**NEW YORK STATE THRUWAY AUTHORITY
DEPARTMENT OF ENGINEERING**

**AMENDMENT NO. 1
TO**

**CONTRACT TAB 25-13
D215028
PAVEMENT REHABILITATION, SAFETY IMPROVEMENTS
AND MISCELLANEOUS WORK ON I-90
FROM MILEPOST 419.4 TO 425.9
IN THE BUFFALO DIVISION
OF THE NEW YORK STATE THRUWAY
IN ERIE COUNTY**

**IN THE LETTING OF
NOVEMBER 19, 2025**

TITLE OF PROJECT I-90 EB AND WB PAVEMENT REHABILITATION	CONTRACT NUMBER: TAB 25-13
LOCATION OF PROJECT MP 419.4 - 425.9	DATE: JULY 2025
TITLE OF DRAWING TYPICAL SECTION SHEET 13 OF 19	DRAWING NUMBER: TYP-13

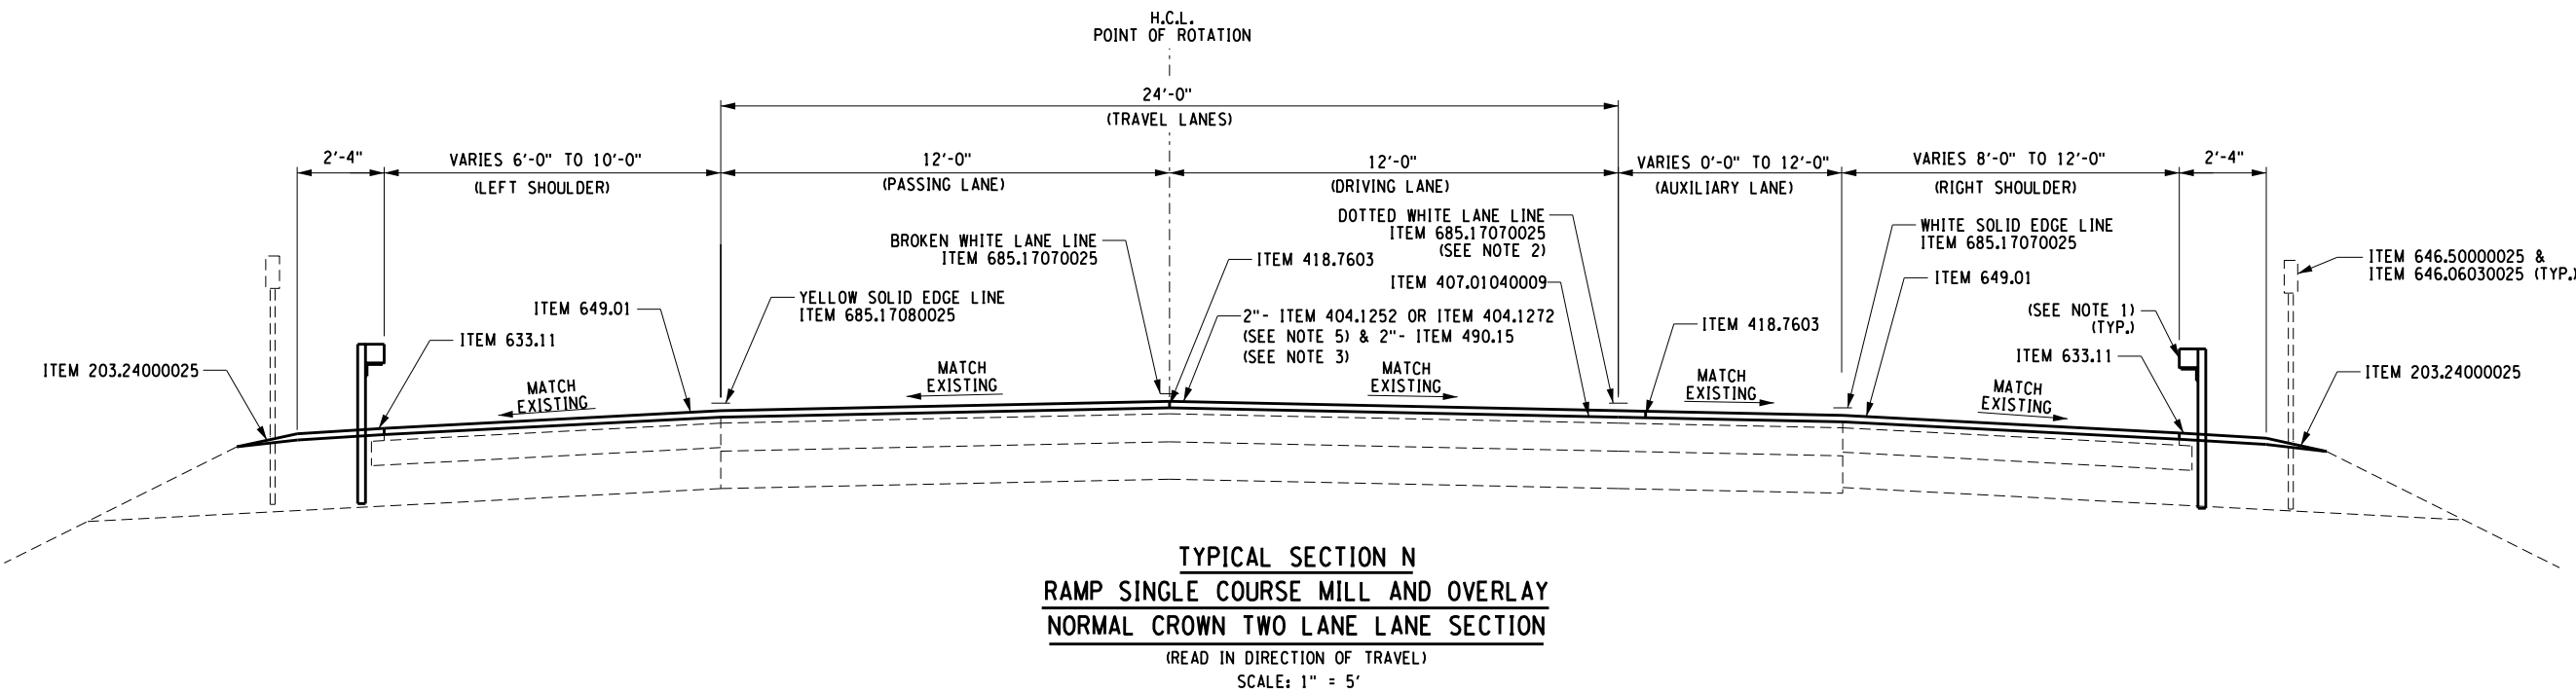
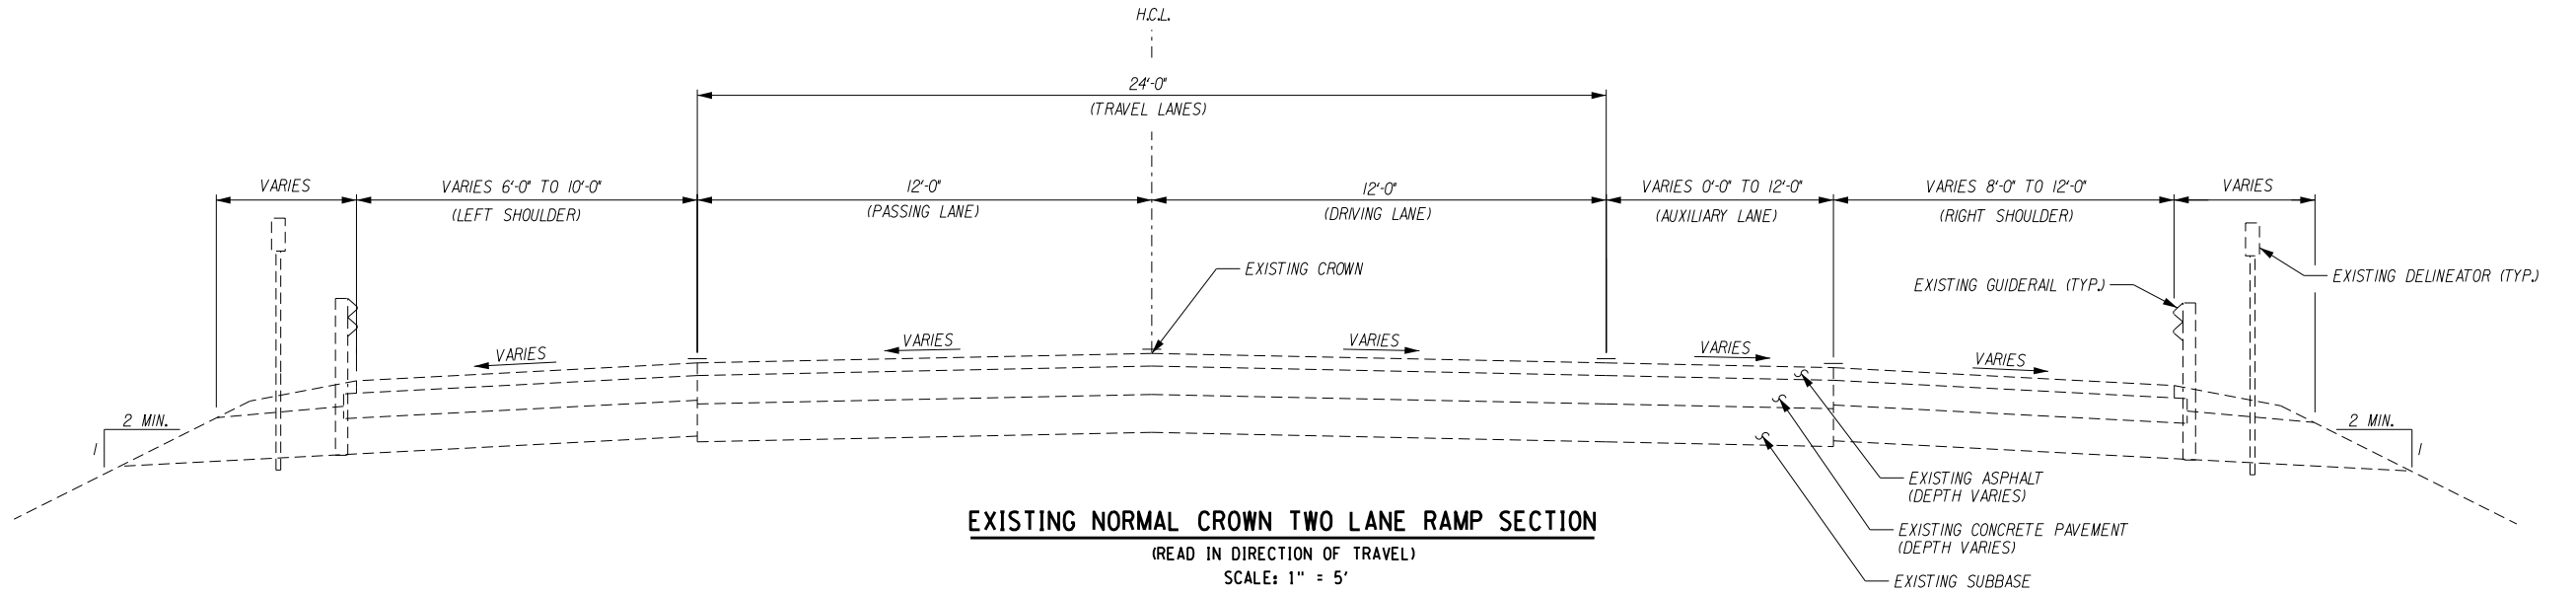
7. **DELETE** Drawing Number TYP-11, Sheet 15 of 371, and **SUBSTITUTE** with the attached Drawing Number TYP-11, Sheet 15-A1 of 371. Notes were added to clarify the use of Items 404.1252 and 404.1272.
8. **DELETE** Drawing Number TYP-13, Sheet 17 of 371, and **SUBSTITUTE** with the attached Drawing Number TYP-13, Sheet 17-A1 of 371. Notes were added to clarify the use of Items 404.1252 and 404.1272.

TITLE OF PROJECT I-90 EB AND WB PAVEMENT REHABILITATION	CONTRACT NUMBER: TAB 25-13
LOCATION OF PROJECT MP 419.4 - 425.9	DATE: JULY 2025
TITLE OF DRAWING TYPICAL SECTION SHEET 14 OF 19	DRAWING NUMBER: TYP-14

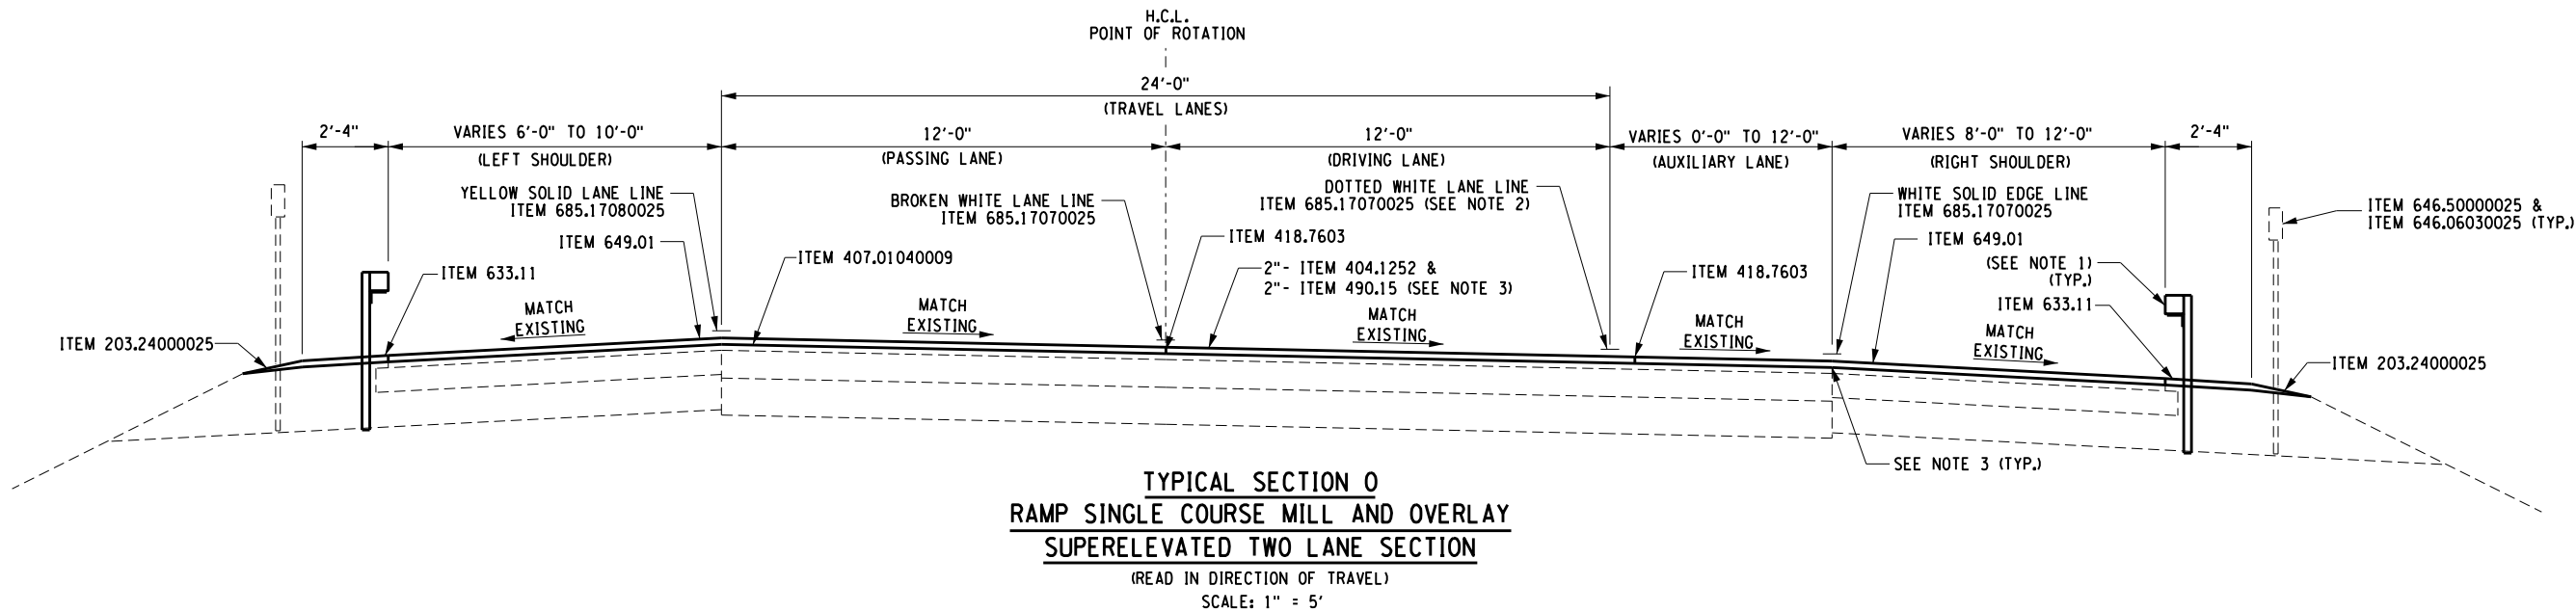
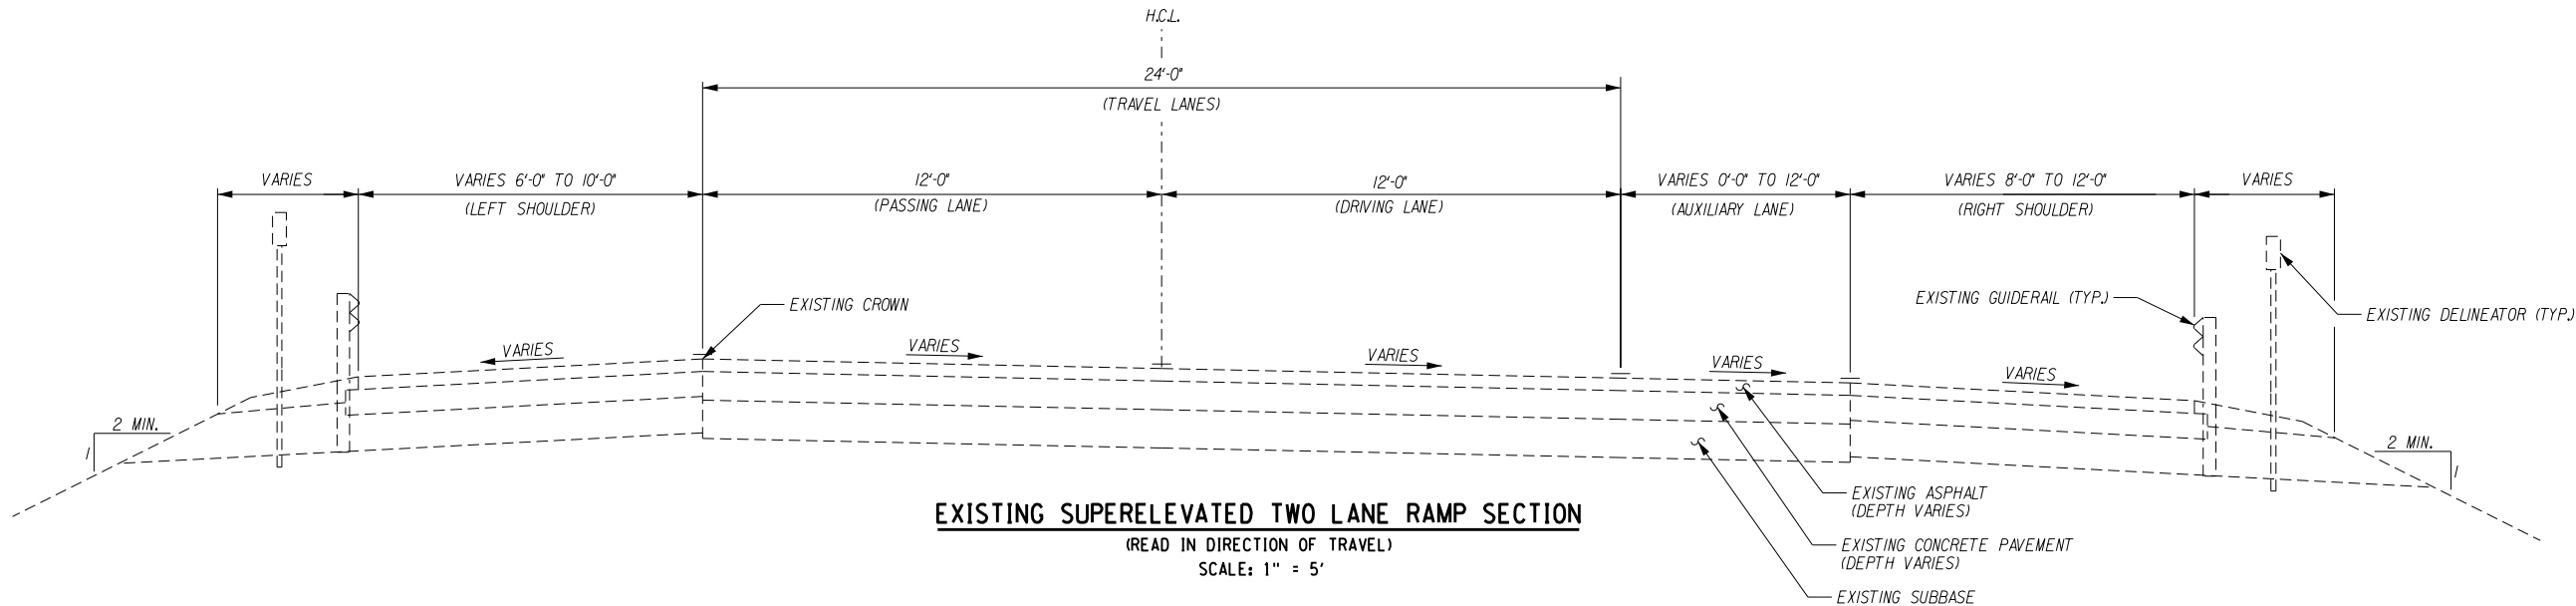
9. **DELETE** Drawing Number TYP-14, Sheet 18 of 371, and **SUBSTITUTE** with the attached Drawing Number TYP-14, Sheet 18-A1 of 371. Notes were added to clarify the use of Items 404.1252 and 404.1272.

TITLE OF PROJECT MP 419.4 - 425.9 PAVEMENT REHABILITATION	CONTRACT NUMBER: TAB 25-13
LOCATION OF PROJECT MP 419.4 - 425.9	DATE: JULY 2025
TITLE OF DRAWING TYPICAL SECTION SHEET 15 OF 19	DRAWING NUMBER: TYP-15

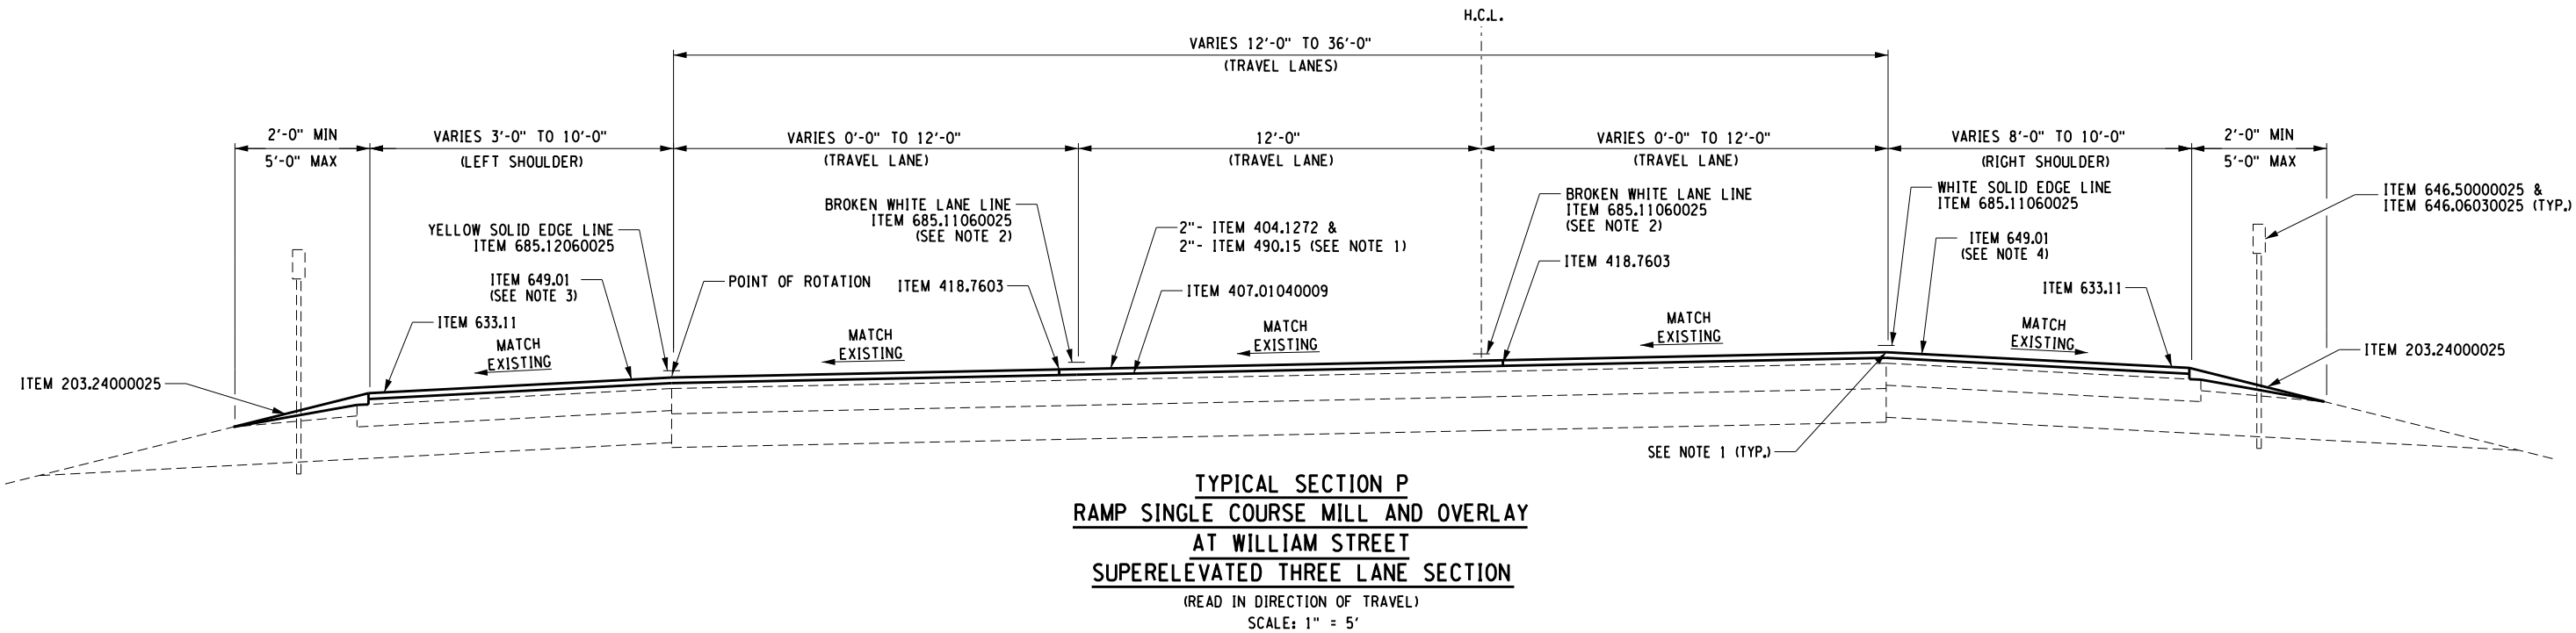
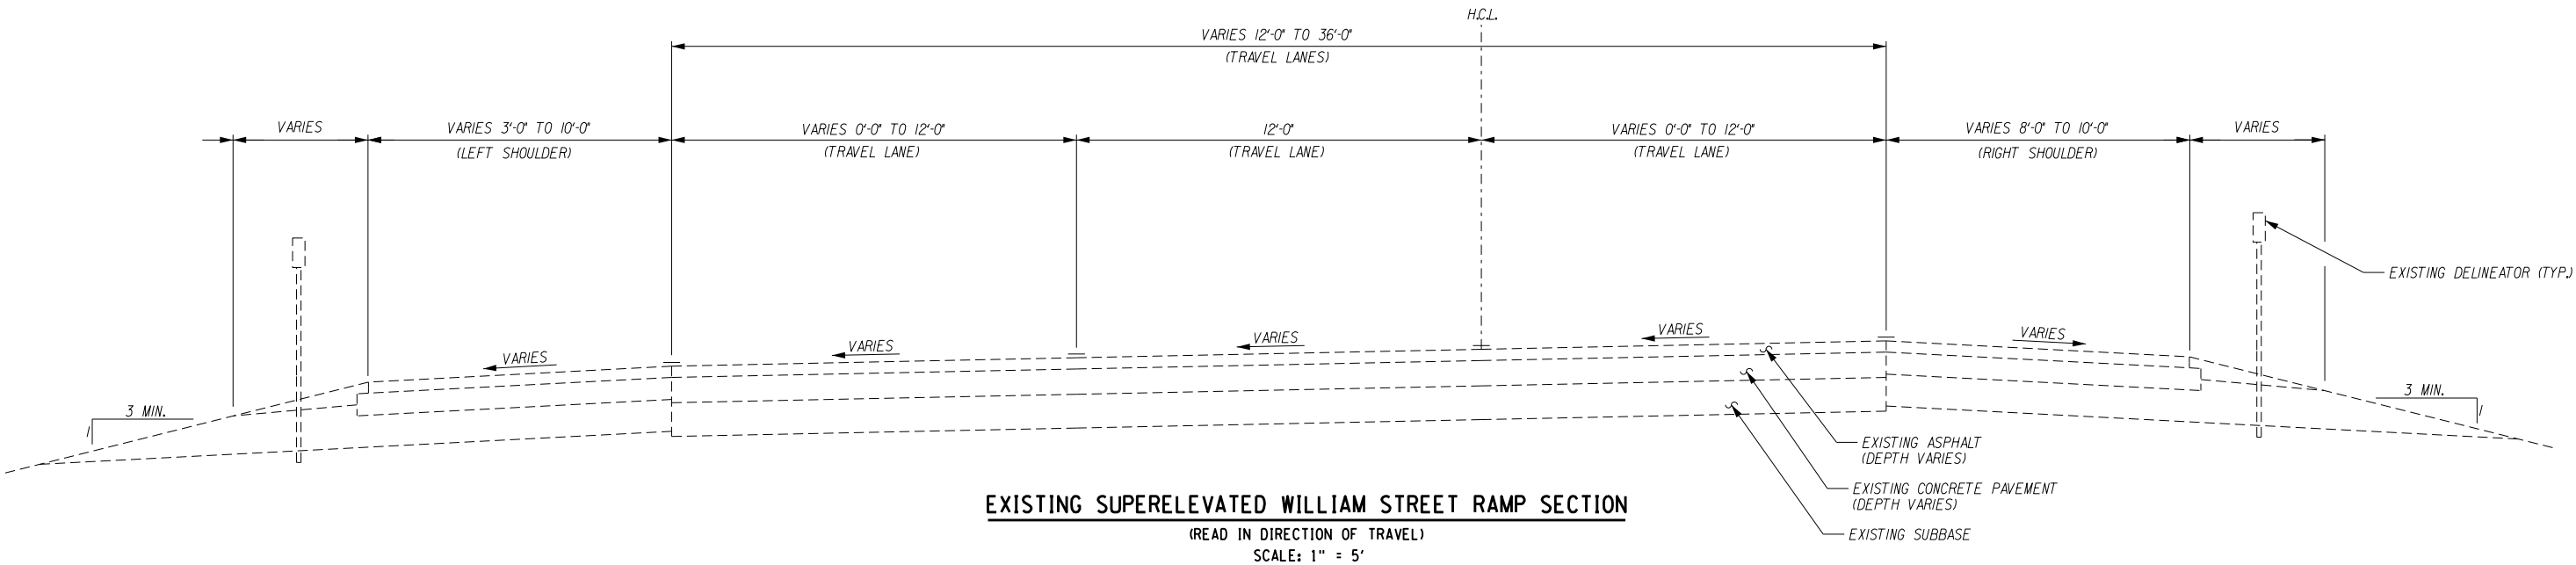
10. **DELETE** Drawing Number TYP-15, Sheet 19 of 371, and **SUBSTITUTE** with the attached Drawing Number TYP-15, Sheet 19-A1 of 371. Notes were added to clarify the use of Items 404.1252 and 404.1272.

NEW YORK STATE Thruway Authority	TITLE OF PROJECT I-90 EB AND WB PAVEMENT REHABILITATION	CONTRACT NUMBER: TAB 25-13
	LOCATION OF PROJECT MP 419.4 - 425.9	DATE: JULY 2025
 MOTT MACDONALD	TITLE OF DRAWING MISCELLANEOUS DETAILS 1 OF 8	DRAWING NUMBER: MSD-1

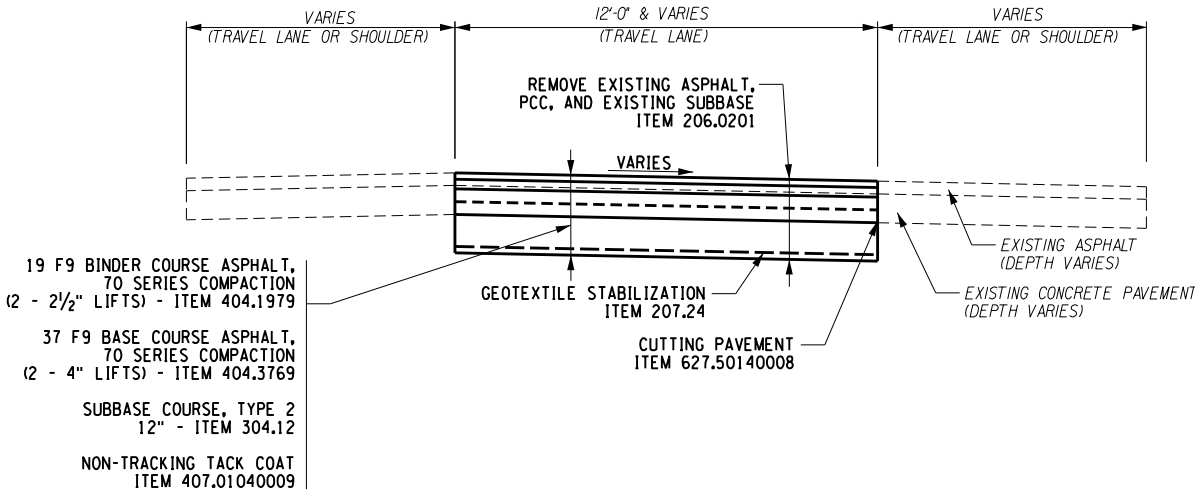
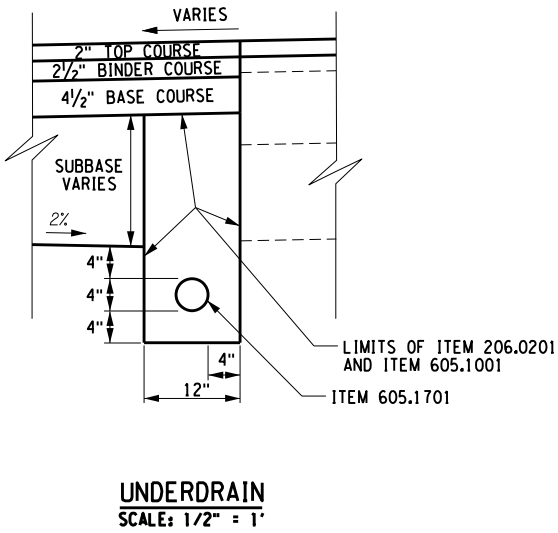
16. **DELETE** Drawing Number MSD-1, Sheet 143 of 371, and **SUBSTITUTE** with the attached Drawing Number MSD-1, Sheet 143-A1 of 371. Reference to Barrier Item 606.3041 was removed from the “Inlet Protection” Detail.

PRECAST PIER PROTECTION BARRIER DETAIL

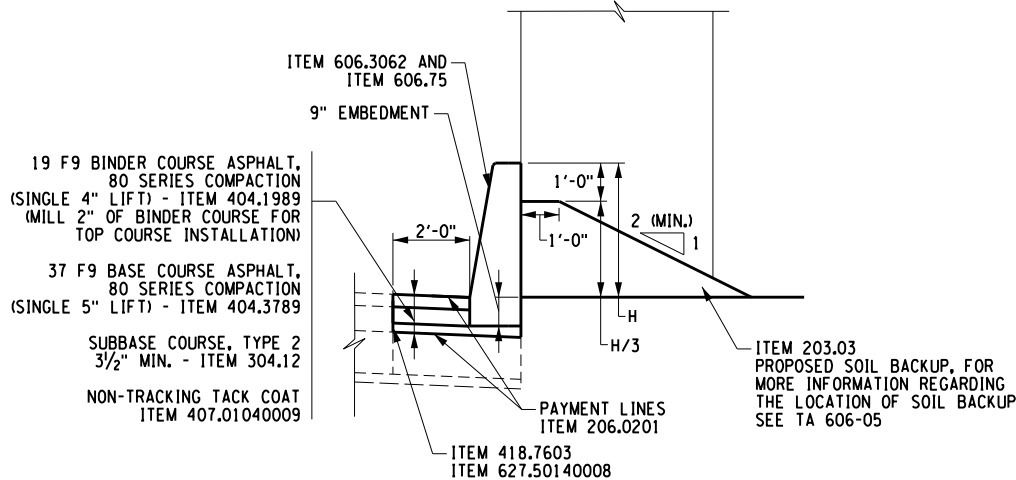
17. **DELETE** Drawing Number MSD-2, Sheet 144 of 371, and **SUBSTITUTE** with the attached Drawing Number MSD-2, Sheet 144-A1 of 371. The “Precast Pier Protection Barrier Detail” has been modified to show the dimensions and pay item for the required soil backup.
